SUBJECT: Transmittal of Comments on the University Boulevard Corridor Plan

SUBJECT: University Boulevard Corridor Plan
Public Hearing Draft – Department of Transportation Comments Follow-up

SUBJECT: University Boulevard Corridor Plan
Public Hearing Draft – Department of Transportation Comments

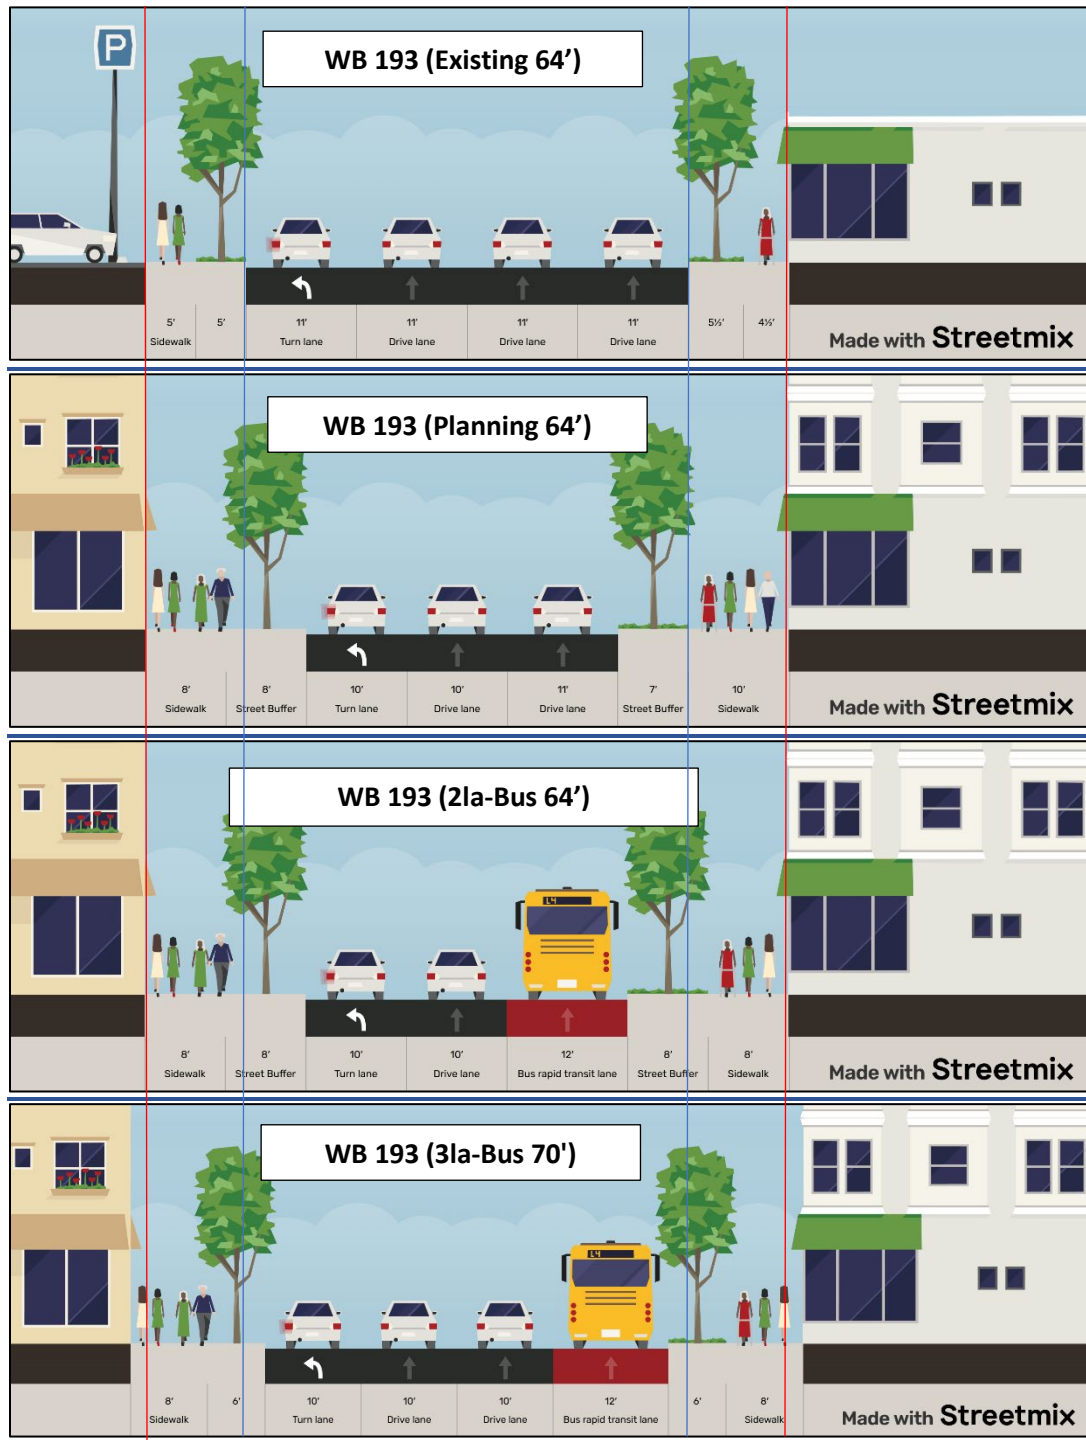
- 1) **TRANSIT LANES IN FOUR CORNERS:**^{18,19,30} We strongly recommend that dedicated bus lanes be provided through Four Corners. Bus lanes are among our top priorities through Four Corners as this corridor already carries very high passenger volumes and provides important regional connectivity. Recent ridership data from WMATA shows ridership almost 40% above pre-pandemic levels. The County worked with the State to install dedicated bus lanes along the portion of University Boulevard between Amherst Avenue and Dennis Avenue. Extending these bus lanes through Four Corners will enhance the current investment in prioritizing transit along the corridor. These lanes will support other goals of the plan, including:

- The higher densities proposed by the Plan's zoning are justified on the basis of high-quality bus services. Bus treatments are key for maintaining on-time performance and making transit a viable and desirable transportation option.

- Without significant improvements to transit, driving will remain the mode of choice along the corridor, which will undermine the Plan's goals of improving multimodal safety, livability, walkability, and bikeability.

- Transit lanes would boost the County's ability to meet the Plan Vision (p11) seeking to "leverage new transit infrastructure to reduce carbon emissions and advance the county's Climate Action Plan (CAP) goals", and also to support the Thrive Montgomery 2050 goal to "make transit the fastest, most convenient, and most reliable way to travel" to activity centers.

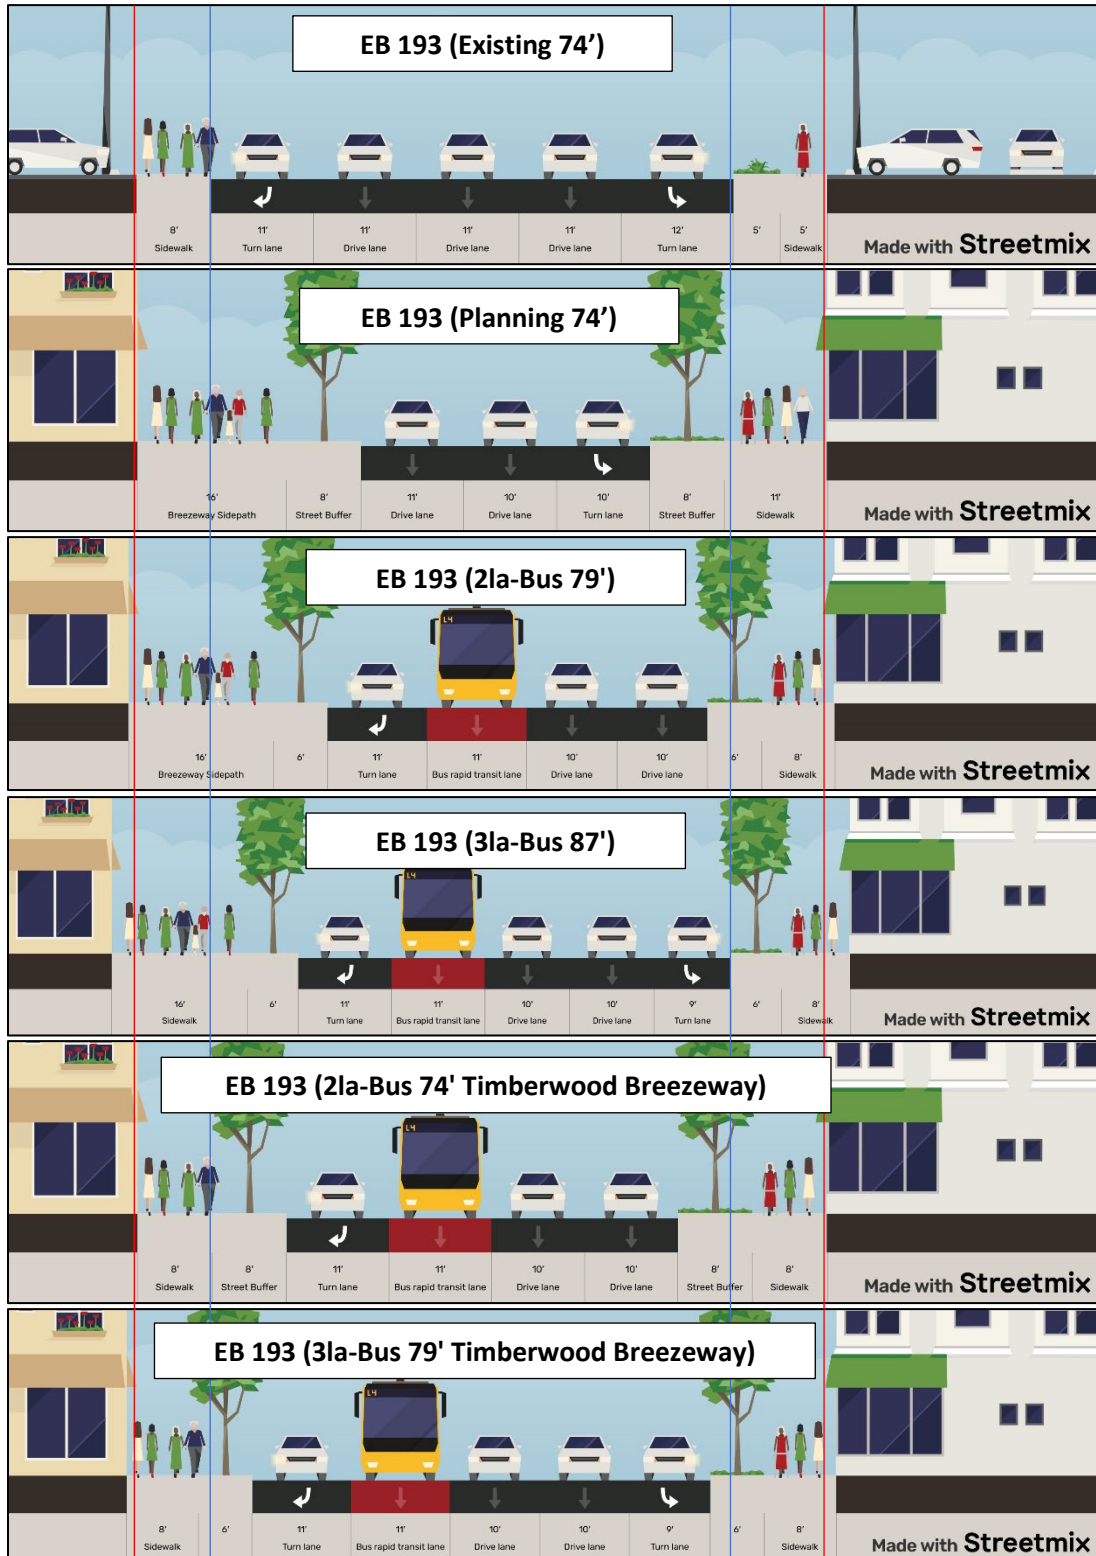
The cross-sections on the next two pages offer some potential options. In the westbound direction, our preference is for an additional bus lane necessitating +3’ on each side of the rights-of-way. In the eastbound direction, our preference is for an additional bus lane and a dedicated right-turn lane (as to remove right-turns from the bus lane), necessitating +6.5’ on each side of the rights-of-way.

Additional width beyond the existing rights-of-way can come from easements rather than dedication. While we appreciate the interest to keep the visual nature of the corridor narrowed as much as possible, we do not believe that the additional widths compromise this interest in our efforts to achieve other plan goals.

If necessary for additional space: consider potential bikeway options parallel to University Blvd which might accommodate Breezeway-level design parameters. One such option might use Timberwood Avenue, transitioning at the west through North Four Corners Local Park, and at the east via Pierce Dr / Lexington Dr. (shown in **blue** in the graphic below)

- 3) **PED-BIKE CONNECTIONS:**³³⁻³⁶ Consider adding the following additional connections as ped/bike hard surface trails, with accompanying Shared Road & Trail bikeways following these paths parallel on each side of University Boulevard: *(shown in blue in the graphic below)*

- Linking Gilmore Drive's discontinuities, including through the Mary's Center property as well as the properties just east of Dennis Avenue.
 - Linking Gilmore Drive and Whitehall Street.

- Linking Whitehall Street and Breewood Road.
 - Linking Edgewood Avenue and Whittington Terrace, passing through the Luther Rice Memorial Baptist Church site.

- Linking Whittington Terrace and Arcola Avenue, passing through the Northwood High School site.
